# Work Order ID 99235

Item Name: Crosstube Turning Detail

<b>DART AEROSPACE LTD</b>	<b>Work Order:</b> <i>9233</i>
<b>Description:</b> Crosstube Assembly (205/212 High Aft)	<b>Part Number:</b> D212-664-241
<b>Inspection Dwg:</b> D212-664-241 <b>Rev:</b> D	<b>Page 1 of 2</b>

DRAWING NO. D212-664-241	TITLE CROSSTUBE ASSY (205/212 HI AFT)	REV. D	<b>DART AEROSPACE LTD ENGINEERING ORDER</b>		D.E.O. NO. D212-664-241-D-1	SHEET NO. SHEET 1 OF 2	SCALE NTS
DRAWN	CHECKED	MFG. APPR.	APPROVED	DE APPR.			
DATE 11.04.07	DATE 11.04.11	DATE 11.04.12	DATE 11/04/12	DATE 11.04.12

DETAIL D:  
CROSSTUBE CUFF D8-4  
SCALE 5X

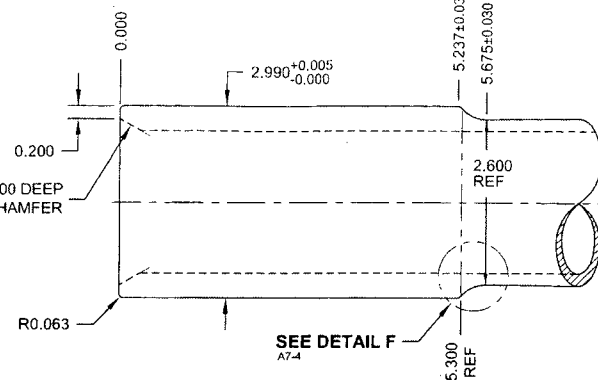
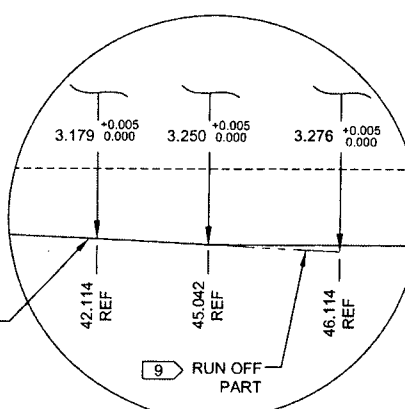
Root Cause		Date	Step	Qty	Description of work order update or Non-conformance	Initial Chief Eng	Action Description	Sign & Date	Verification	QC Inspector
Doc/Data		13/5/16	100	1	One cuff is 4.947" long (avg = 5.237")  R.C. Process (material)	GP 13/7/2	Acceptable. Cosmetic only. There is a lot of cuffs above the saddle & this should not be noticeable.	GP 13/7/2	JW 13-07-10	DAS 16 9-89  13/6/30
Equip/Tooling										
Operator										
Material	X									
Setup										
Other										
Process										
Supplier										
Training										
Unapproved

**D212-664-241-241B  
ASSEMBLY DETAIL**

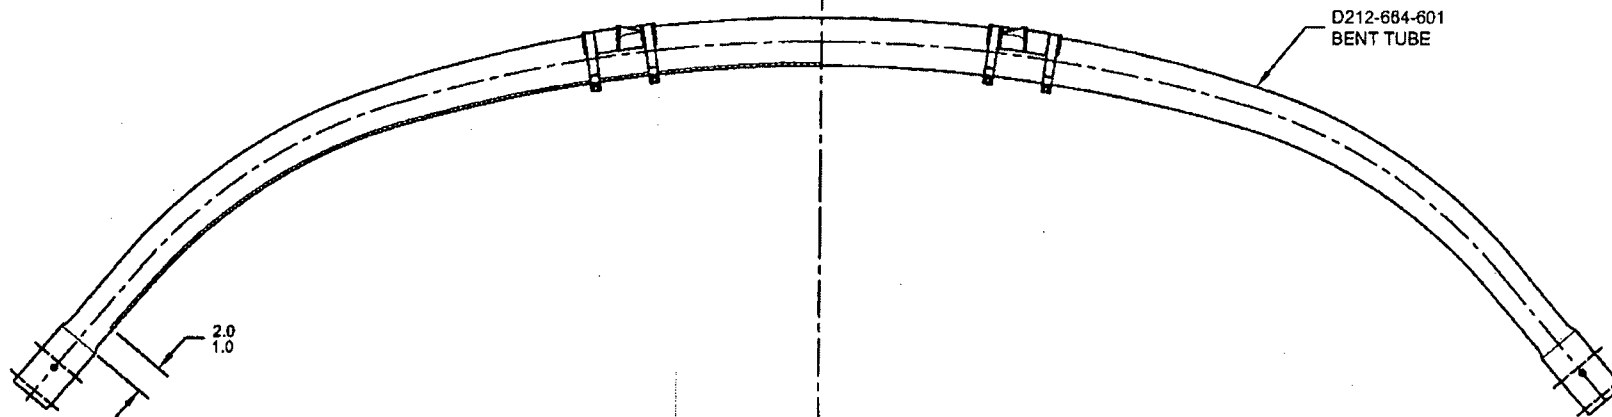
ADD AN INSPECTION WINDOW TO UNDERSIDE OF CROSSTUBE.

NOTES 2 OF SHEET 1 IS AMENDED AS FOLLOWS:

- 2) FINISH: CHEMICAL CONVERSION COAT PER DART QSI 005 4.1  
PRIME INSIDE AND OUTSIDE PER DART QSI 005 4.2  
MASK UNDERSIDE OF CROSSTUBE AS SHOWN (HATCHED AREA) AND  
PAINT OUTSIDE PER DART QSI 005 4.2  
REMOVE MASKING AND APPLY CLEAR COAT

MASK AREA PRIOR TO PAINTING,  
REMOVE MASKING AFTER PAINT  
AND APPLY CLEAR COAT
